Upper Heaton Accessibility Action Plan April 2023

4.1 - ACTION TABLE

13.11

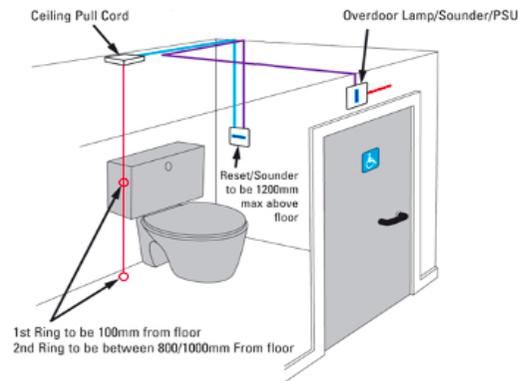
The cord alarm in reception was not freely hanging within a suitable distance of the floor.

The cord alarm on the first-floor facility was marginally high from ground floor level.

The cord alarm in the hygiene room was looped around a grab rail.

The cord alarm in the facility near to the dining area was marginally high from ground floor level.

If cord alarms are not hanging within a suitable distance of the floor, distress calls may go unnoticed.

Implement a management procedure to ensure that cord alarms are always kept loose and not tied up.

According to BS8300 - An emergency assistance pull cord should be sited so that it can be operated from the WC and from an adjacent floor area. The emergency assistance pull cord, coloured red, should be provided with two red bangles of 50 mm diameter, one set at a height between 800 mm and 1000 mm and the other set at 100 mm above floor level.

The emergency assistance pull cord's around school are checked weekly as part of the site PPM's. Any that are found to be tied up are untied and left in the correct position. Email sent out to all staff regarding the correct position for The emergency assistance pull cord's 30/01/2024
